Customer	SM Electric	**Location**	Newark Airport Terminal B		
Substation	EMDS-North	**Feeder/Cubicle**	NB / Section #1	**Unique ID**

Site Investigation- Corrosion of Copper Bus bars in Switchgear NB- EWR Terminal B-1
June 14, 2011

NEWARK LIBERTY INTERNATION AIRPORT
TERMINAL B LOWER LEVEL EXPANSION
EWR-264.003

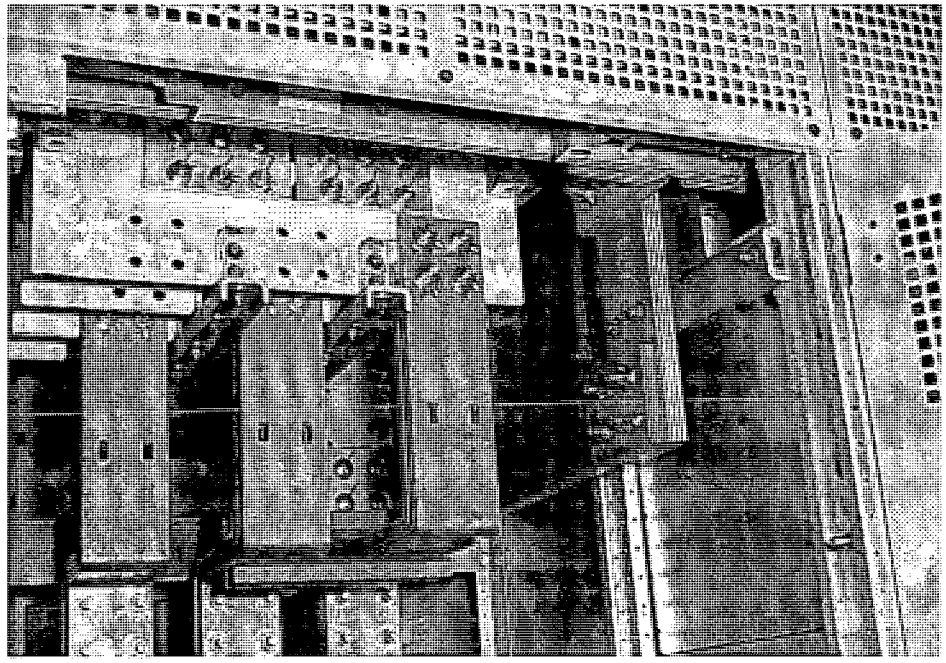
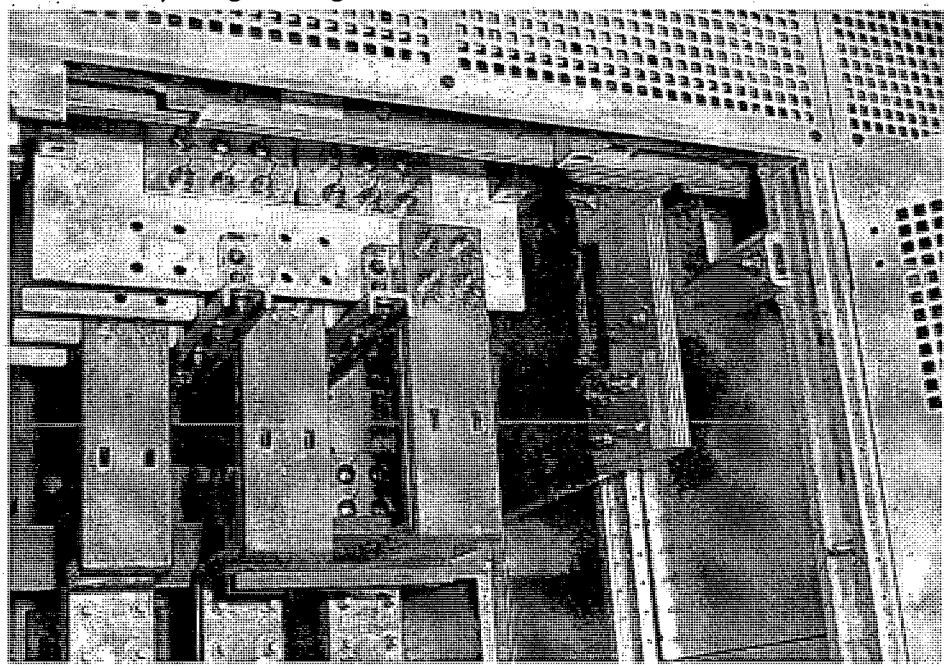
1. Switchgear NB (south end) - condition of bus bars generally good, some residual staining from loss of silver plating. Plating is still evident around bolted connections.

1. Switchgear NB (south end) - condition of bus bars generally good, some residual staining from loss of silver plating. Plating is still evident around bolted connections.

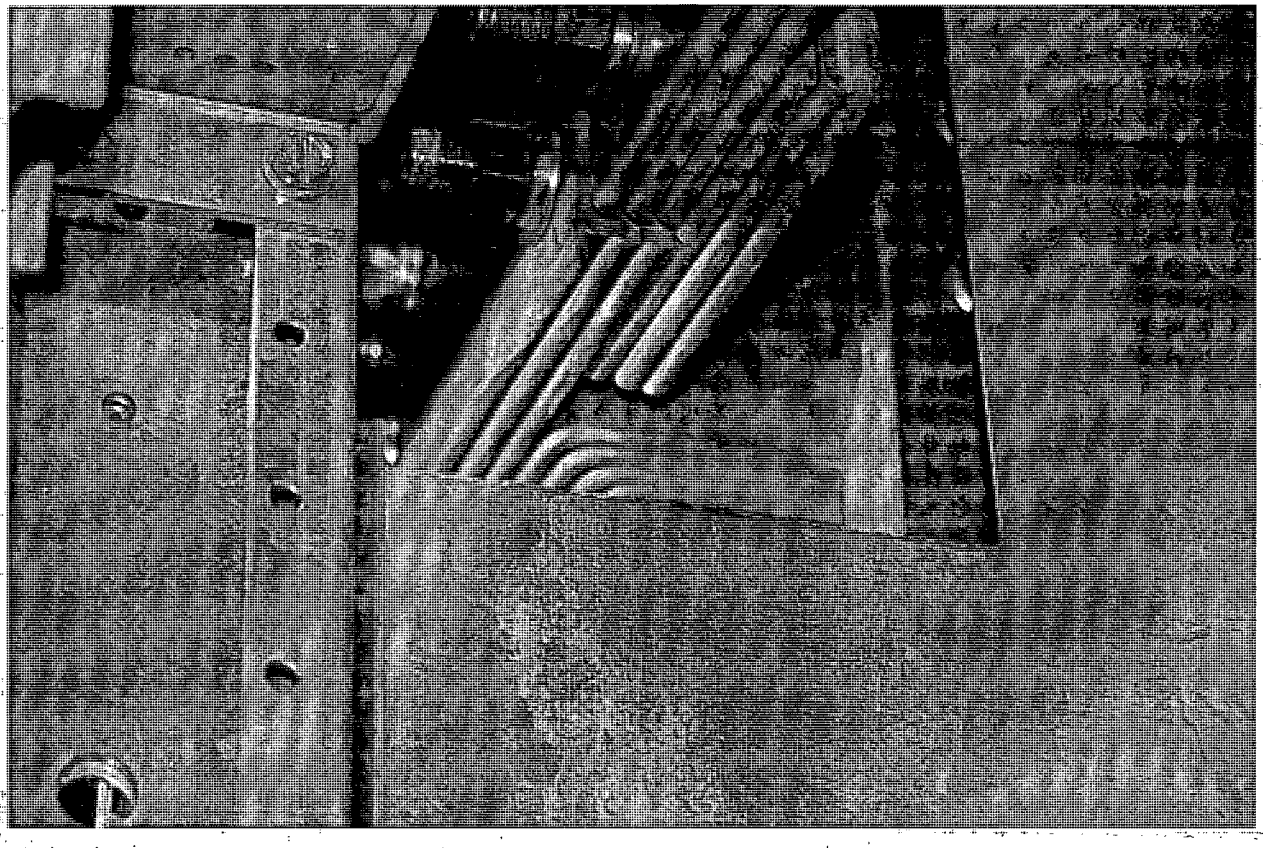
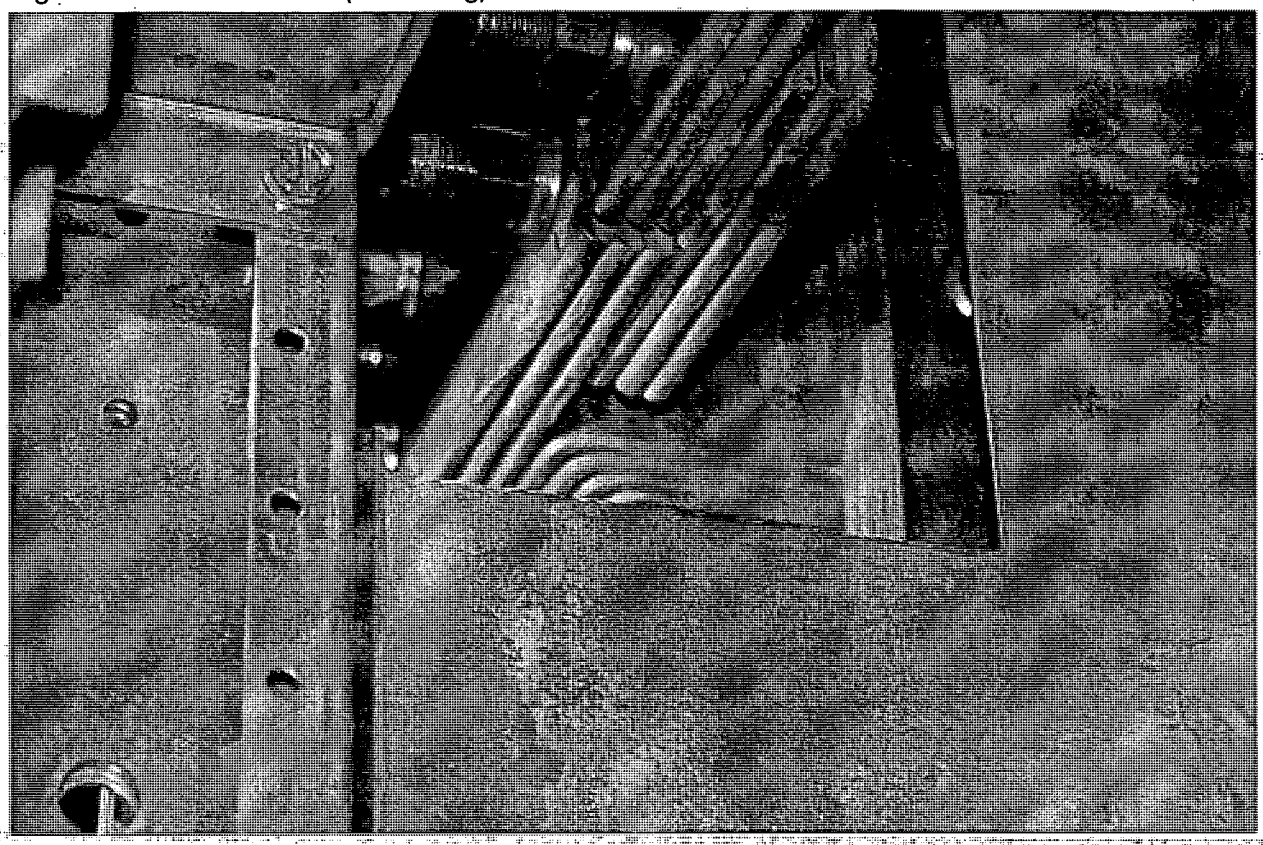
2. On horizontal bus bars between adjacent cabinets, joints and link bars show greenish scale on edges. Condition of interior (contacting) surfaces is not known.

2. On horizontal bus bars between adjacent cabinets, joints and link bars show greenish scale on edges. Condition of interior (contacting) surfaces is not known.

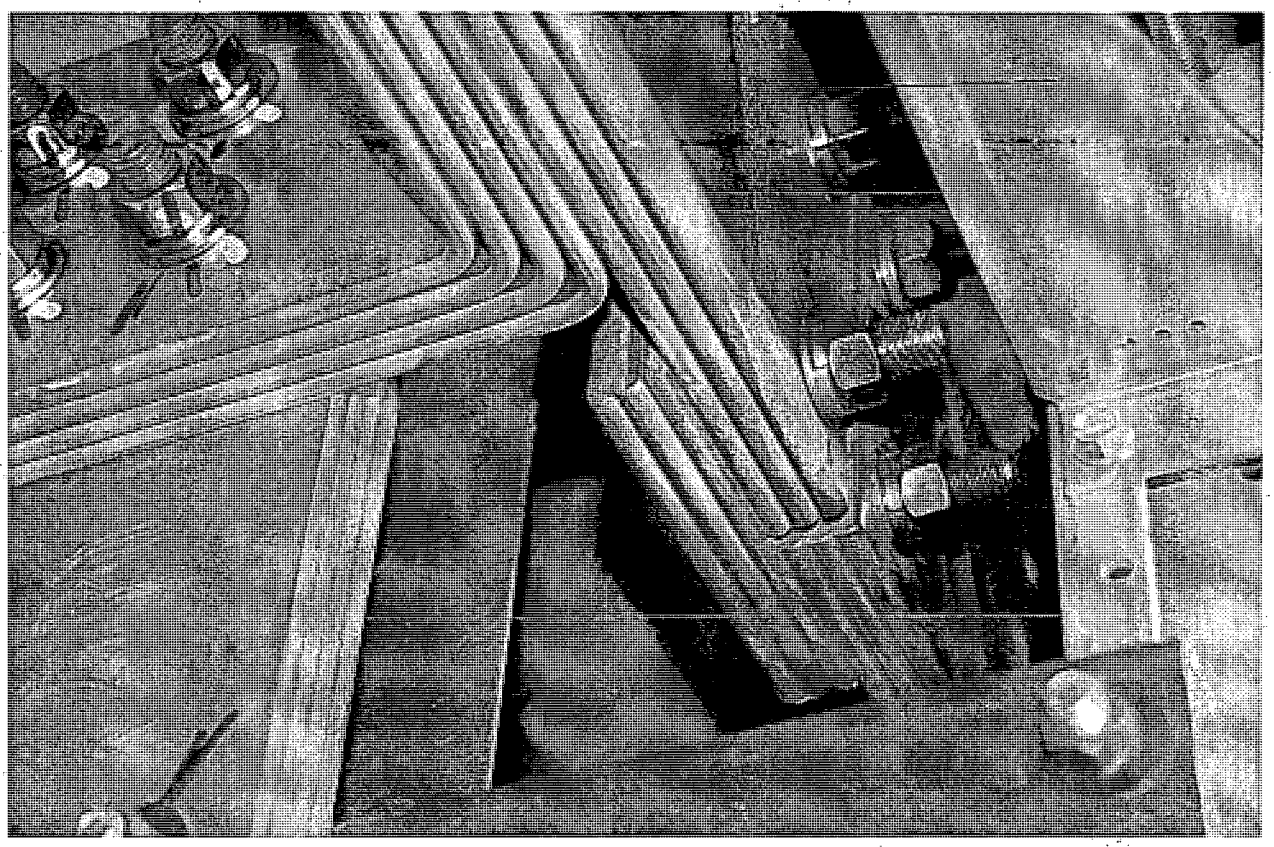
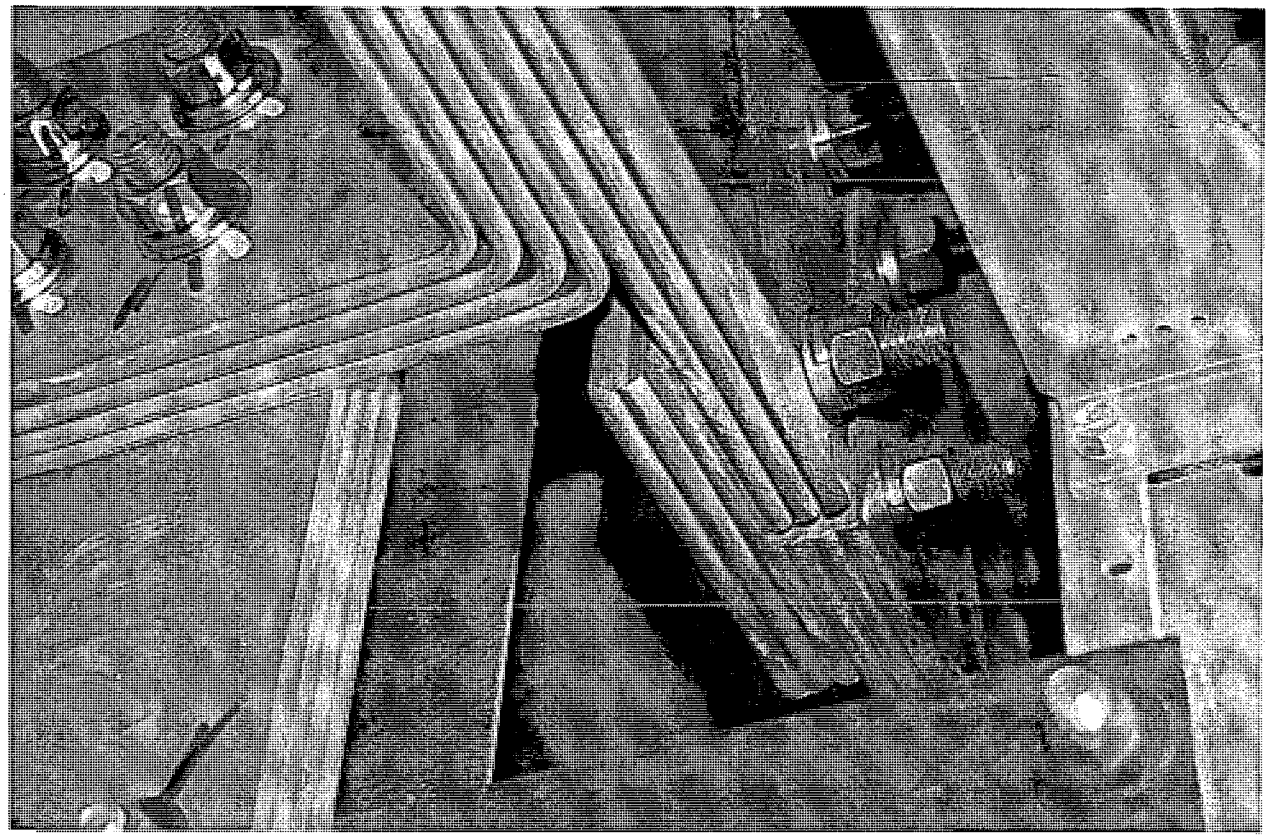
3. Most significant observation is appearance of a very localized scale-like green deposit, which appears to be the result of a residue left when attempts were made to clean the bus bars. Is this deposit the result of a cleaning chemical/compound used to clean the oxidation originally observed, from the bars?

3. Most significant observation is appearance of a very localized scale-like green deposit, which appears to be the result of a residue left when attempts were made to clean the bus bars. Is this deposit the result of a cleaning chemical/compound used to clean the oxidation originally observed, from the bars?

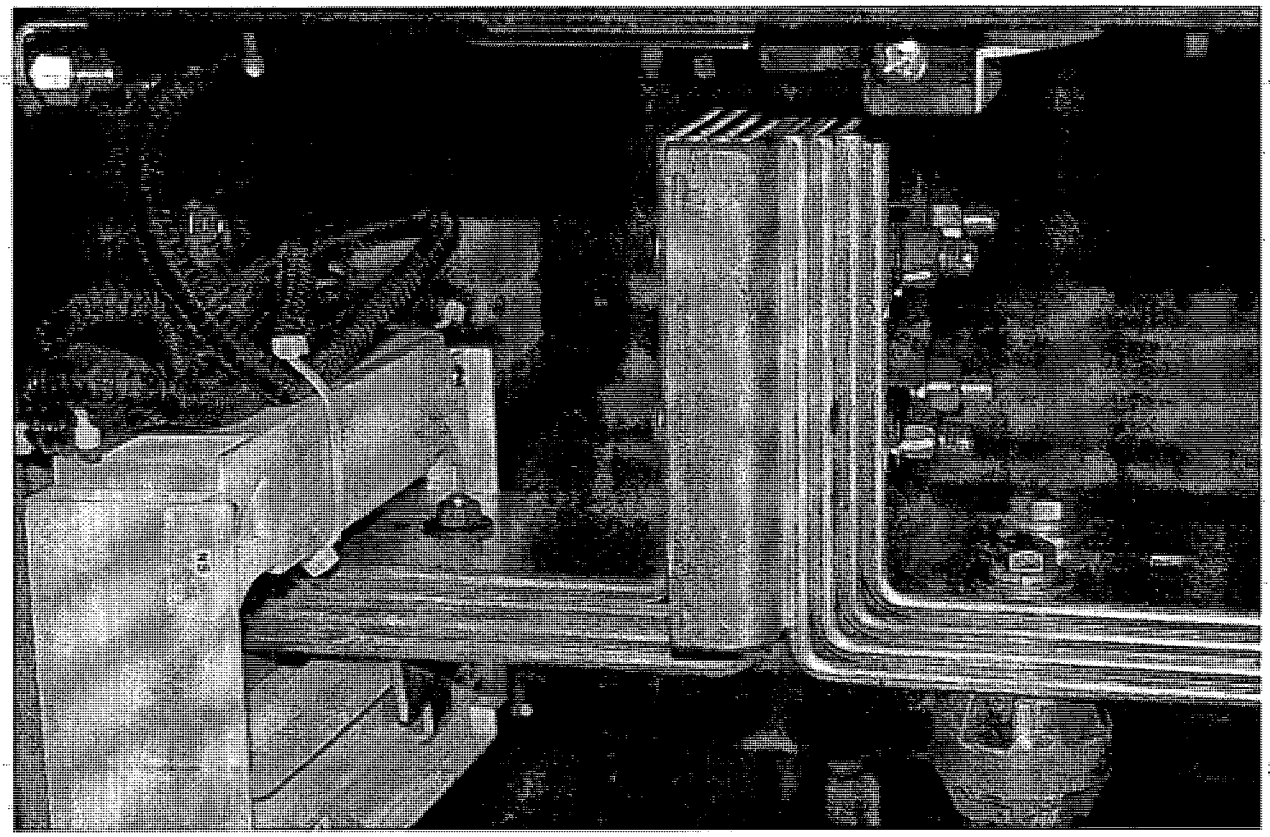
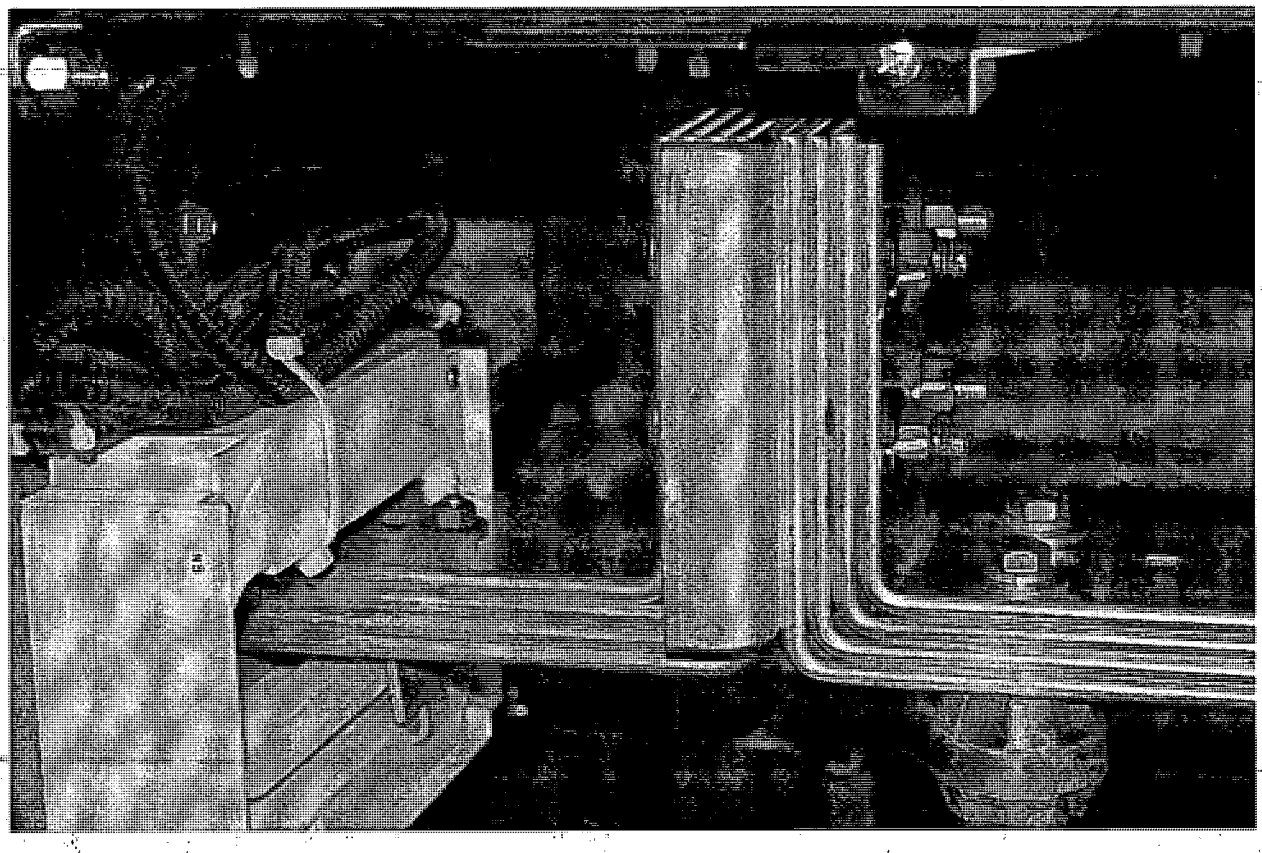
4. Another significant finding- Bus bars inside the Switchboard B2 cabinets are pristine- no evidence of loss of plating, no corrosion products. What was different about the storage of this equipment compared to NB?

4. Another significant finding- Bus bars inside the Switchboard B2 cabinets are pristine- no evidence of loss of plating, no corrosion products. What was different about the storage of this equipment compared to NB?

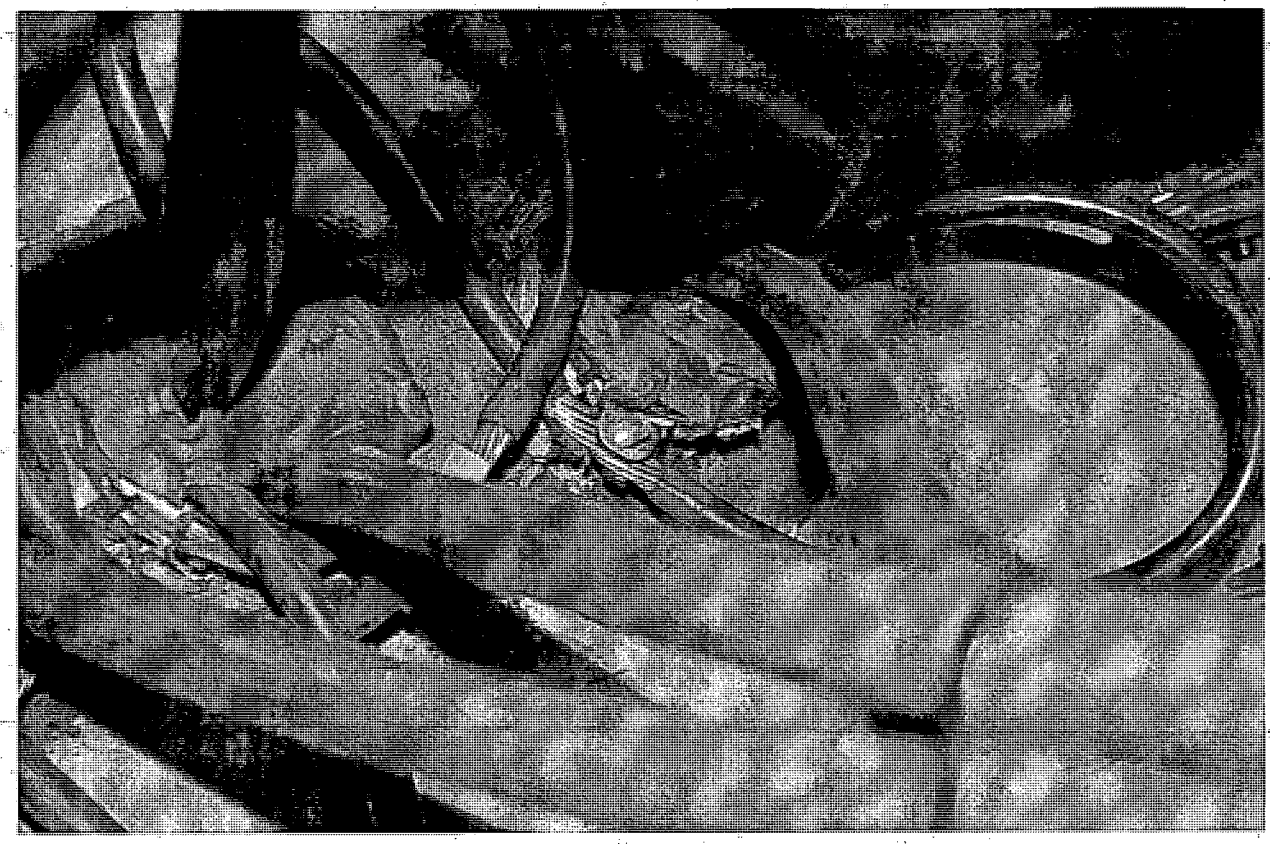
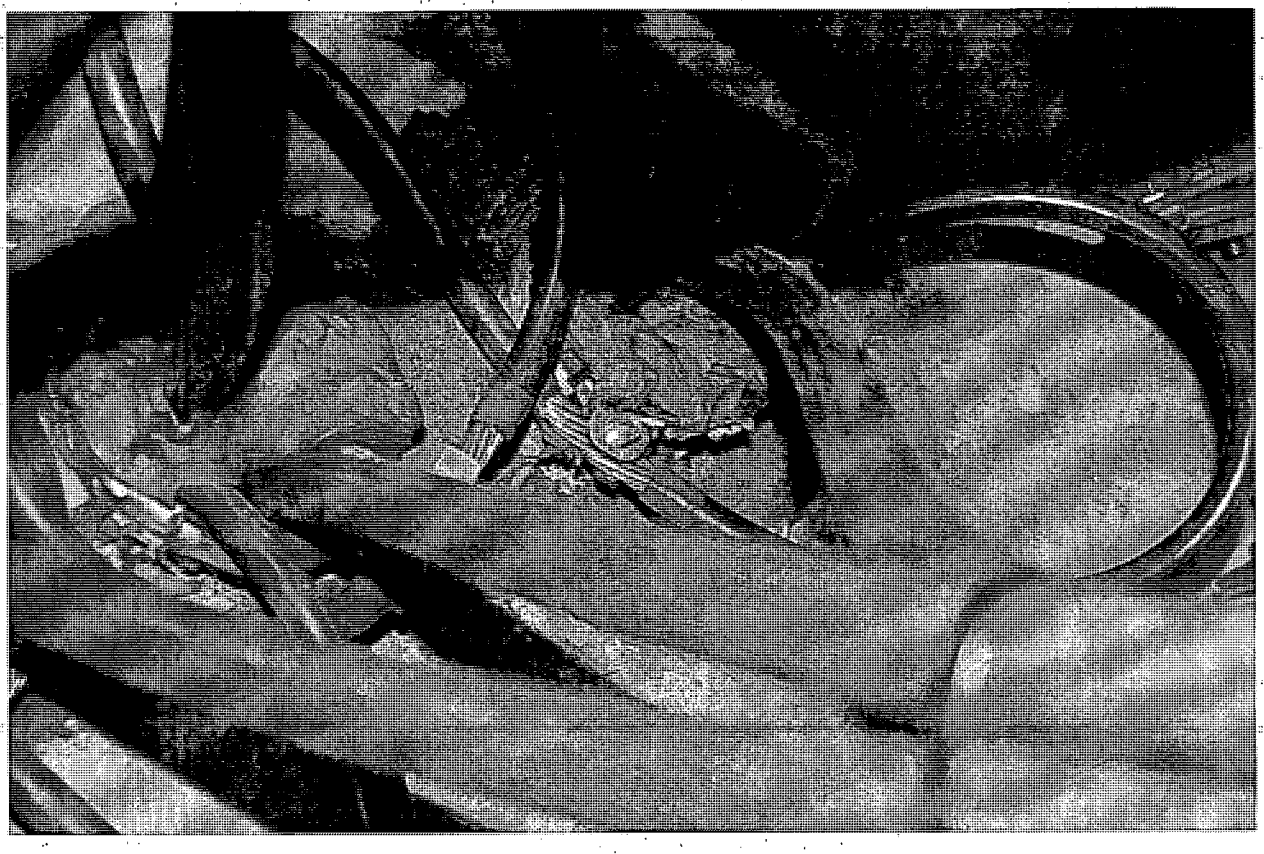
5. Additional observation- conduits enter Switchgear NB cabinets from bottom, up from crawl space below- Is there an atmosphere containing moisture, and contaminants that is coming through the conduits? Note that the sealing the conduits is not necessarily effective due to gaps. Also note the corrosion of the bottom of the enclosure surrounding the conduit entrance.

5. Additional observation- conduits enter Switchgear NB cabinets from bottom, up from crawl space below- Is there an atmosphere containing moisture, and contaminants that is coming through the conduits? Note that the sealing the conduits is not necessarily effective due to gaps. Also note the corrosion of the bottom of the enclosure surrounding the conduit entrance.
